## **Go-Ahead Bus Depot, Ballymount Road Lr., Dublin 12**

Engineering Response to Request for Additional Information.  
(Reg Ref SD21A/0213)

**Client Name:** Go-Ahead Ireland  
**Document Reference:** 17-130r.014  
**Project Number:** 17-130

Figure 2 Waterman Moylan Drg No 17-130/P250 Elevations – Existing  
(No changes proposed as part of this application)

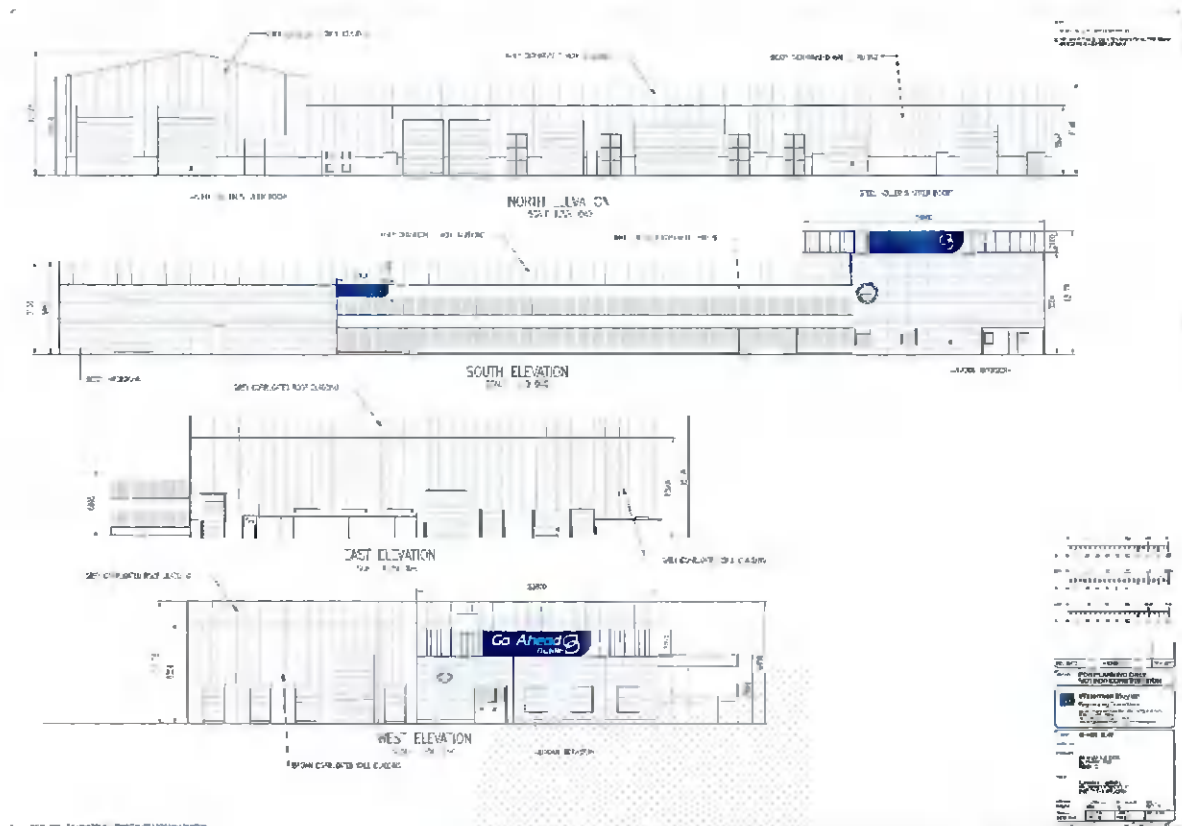
1. The Planning Authority has concerns regarding the visual impact of the proposed development. The applicant is requested to provide the following information, to enable full assessment of the visual impact:

1. 'As permitted' elevations (under SD17A/0428).

#### (a) Waterman Moylan Drg No 17-130/P250 Elevations – Existing

This drawing was prepared from Waterman Moylan Drg No 17-130/P106 Elevations – Existing included with the subject planning application lodged in (Reg Ref SD21A/0428)

It shows the existing elevations in 2021. No changes are proposed as part of this application.

Figure 4 Waterman Moylan Drg No 17-130-P200A Proposed Surface Water Drainage Layout

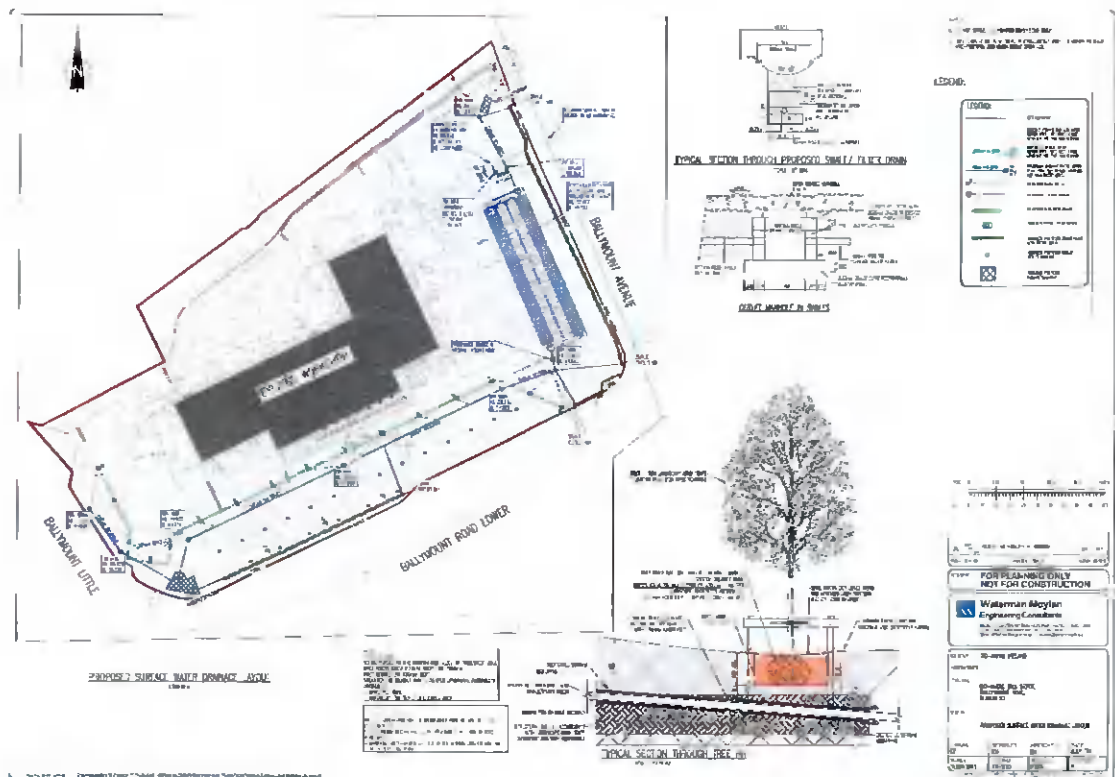
*The current drainage scheme does not fully comply with the objectives of the development plan in terms of Green Infrastructure or as regards the proper implementation of SUDS. There is a lack of SuDS (Sustainable Drainage System) or natural solutions shown for the proposed development. Natural SUDS features should be incorporated into the proposed drainage system. SUDS should be an integrated multi-disciplinary approach which locally addresses water quality, water quantity, and provides for amenity and biodiversity enhancement which meets the objectives of South Dublin County Council Development Plan 2016-2022. The applicant is requested to submit a revised drawing and report to clearly show what SuDS are proposed for the development.*

This Response comprises a report and revised drawing and to clearly show what SuDS measures are proposed for this development. The text of the report is set out below and Waterman Moylan Drg No 17-130-P200 Rev A *Proposed Surface Water Drainage Layout* is included with the Response. See Figure

The subject site is particularly constrained in relation to free area available to implement SuDS measures as the site is already currently mainly hardstanding. In order to facilitate the extension of existing yard slab areas to provide the additional parking areas, a further extension of hardstanding areas is required. This has in turn reduced the available area to provide SuDS measures on site.

Swales have been included along the outer edge of the proposed extended concrete slab on the eastern and southern boundaries to intercept runoff and promote infiltration. Please see Drawing No 17-130-P200 A for the location of these.

Tree pits have been included at the south-western corner and north-eastern corners of the extended slab to intercept runoff and promote infiltration. Please see Drawing 17-130-P200A for the location of these.

In compliance with the RFI, the Petrol Interceptor, previously located after the proposed attenuation tank system, has been relocated to be prior of the proposed attenuation tank system to assist in reducing the contamination of the proposed attenuation tank system with hydrocarbons. Please see Drawing 17-130-P200A for the revised location of the petrol interceptor.

Surface Water attenuation – Due to insufficient space for detention basins or other SUDS storage measures on the subject site, on-site attenuation is required to allow for temporary storage of the restricted outflow. The proposed Stormtech attenuation tank will attenuate surface water that is above the restricted outflow that is equivalent of the existing agricultural runoff. This ensures the development will not give rise to any impact downstream of the site.

Figure 5 Waterman Moylan Drg No 17-130-P200A Proposed Surface Water Drainage Layout

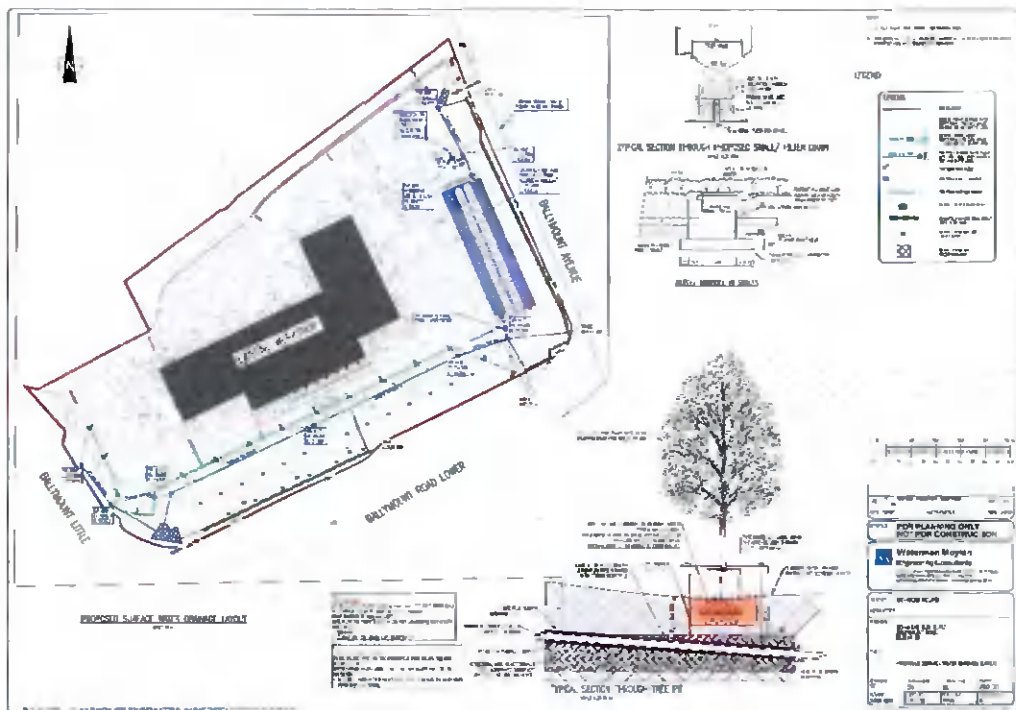
- a. The applicant is requested to submit a revised drawing showing the surface water layout for the development up to and including the point of connection to the public sewer. The drawing should include the location of all AJs, manholes, pipe size, material type and direction of flow.
- b. The applicant is requested to submit a revised drawing showing a petrol interceptor on surface water network prior to surface water entering surface water attenuation system. This is required to reduce the risk of attenuation system being contaminated from hydrocarbons.

In response to this item of the RFI, revised Drg No 17-130/P200A Proposed Surface Water Drainage Layout is included with the Response to the RFI. See Figure 5.

This drawing shows the layout of the proposed surface drainage system including pipe sizes, material type, direction of flow together with the locations of all AJs and manholes.

As requested, the Petrol Interceptor, previously located after the proposed attenuation tank system, has been relocated to be prior of the proposed attenuation tank system. This is to assist in reducing the contamination of the proposed attenuation tank system with hydrocarbons. Please see drawing 17-130-P200 for the location of same.

Figure 6 Waterman Moylan Drg No 17-130/P107A Proposed Site Layout

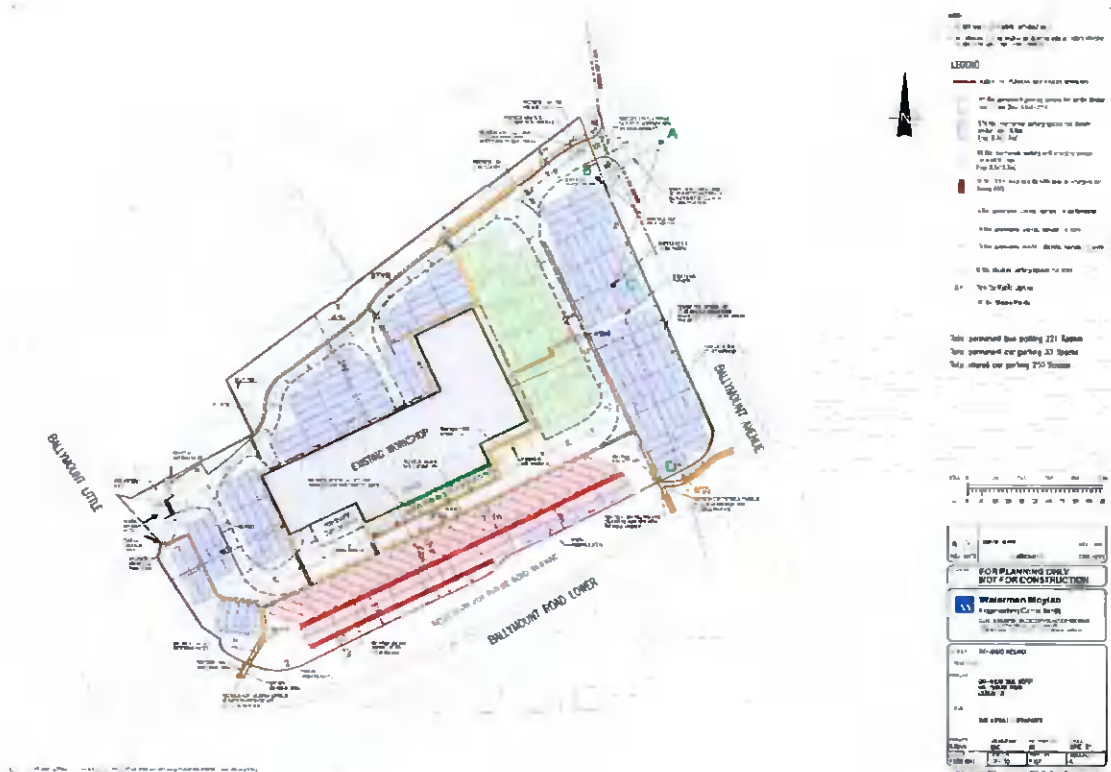
- a. a visibility splay of 2.0m x 45m in both directions from the entrance. Sightlines should be to the near side edge of the road to the right-hand side of entrance and to the centreline of the road to the left-hand side of the entrance (when exiting).

*b. 5% of vehicular parking spaces for mobility impaired users, and 10% vehicular parking spaces to be equipped with electrical charging.*

This drawing shows a visibility splay of 2.4m x 45m in both directions from the proposed new entrance on Ballymount Avenue. The visibility splay was based on sightlines should be to the near side edge of the road to the right-hand side of entrance and to the centreline of the road to the left-hand side of the entrance (when exiting).

The visibility splay has been co-ordinated with the landscape consultants to ensure that there will no above ground planting within the visibility splay.

In compliance with the Development Plan, total of 2 spaces are required to be allocated to mobility impaired users (5%) and a total of 4 spaces to be equipped for electric charging (10%).

The actual provision, as shown on the attached copy of Waterman Moylan Drg No 17-130/P107 Rev A *Proposed Site Layout*, is 4 spaces for mobility impaired, an overprovision of 2 spaces and 15 spaces for electric charging, an overprovision of 11 spaces.

**PROPOSED SURFACE WATER DRAINAGE LAYOUT**  
1:500 @ A1

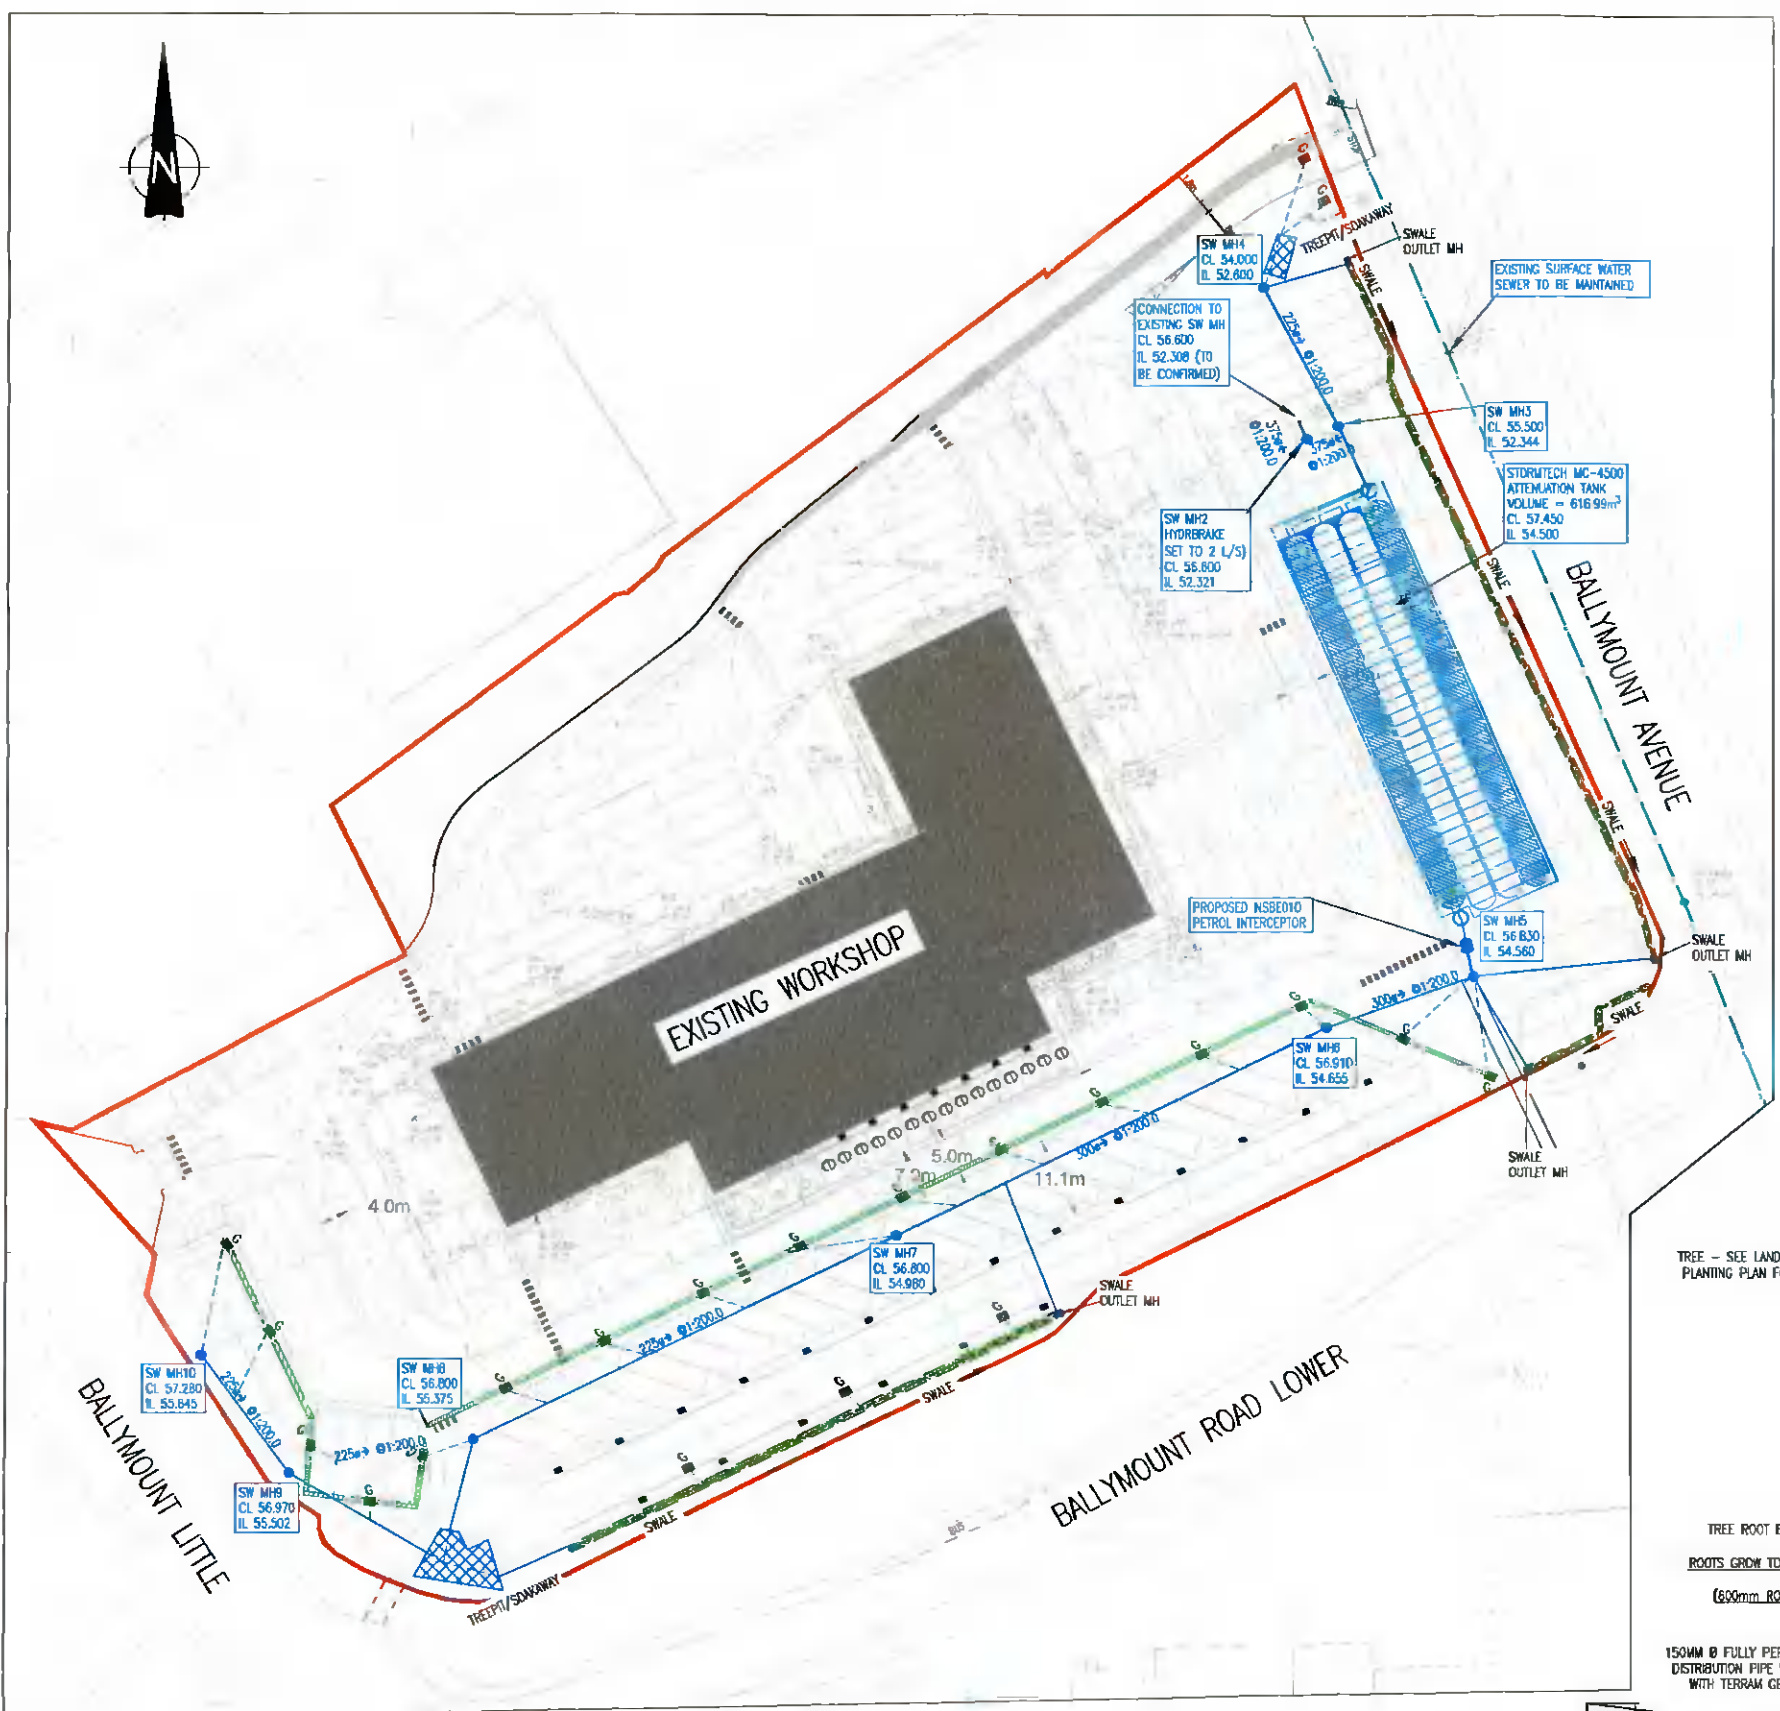
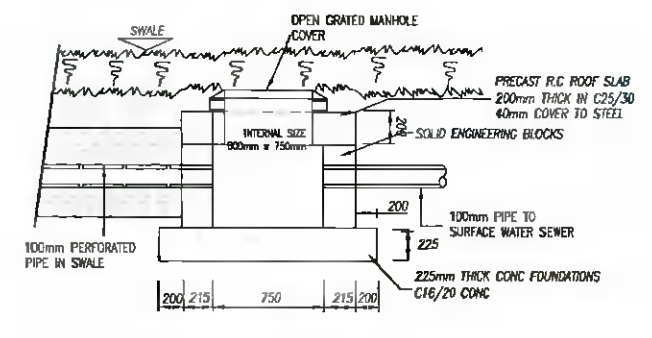
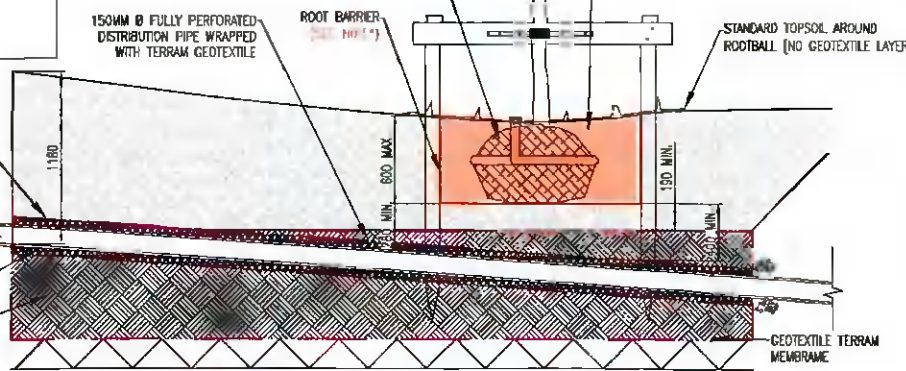
*In accordance with Paragraph 11.6.1(iii) of the County Development Plan, 'In general, all new developments will be required to incorporate Sustainable Urban Drainage Systems (SUDS). SUDS include devices such as swales, permeable pavements, filter drains, storage ponds, constructed wetlands, soakaways and green roofs. In some exceptional cases and at the discretion of the Planning Authority, where it is demonstrated that SUDS devices are not feasible, approval may be given to install underground attenuation tanks or enlarged pipes in conjunction with other devices to achieve the required water quality. Such alternative measures will only be considered as a last resort'. The applicant is requested to omit the proposed attenuation tank and provide sufficient SUDS, unless it can be demonstrated that SUDS are not feasible.*

- Swales – Swales have been included along the outer edge of the proposed extended concrete slab on the eastern and southern boundaries to intercept runoff and promote infiltration. Please see drawing 17-130-P200A for the location of these.

- Tree pit/ Soakaway –Tree pits have been included at the south-western corner and north-eastern corner of the extended slab to intercept runoff and promote infiltration. Please see drawing 17-130-P200 for the location of these

- Petrol Interceptor –the petrol interceptor, previously located after the proposed attenuation tank system, has been relocated to be prior of the proposed attenuation tank system to assist in reducing the contamination of the proposed attenuation tank system with hydrocarbons. Please see drawing 17-130-P200A for the location of these.
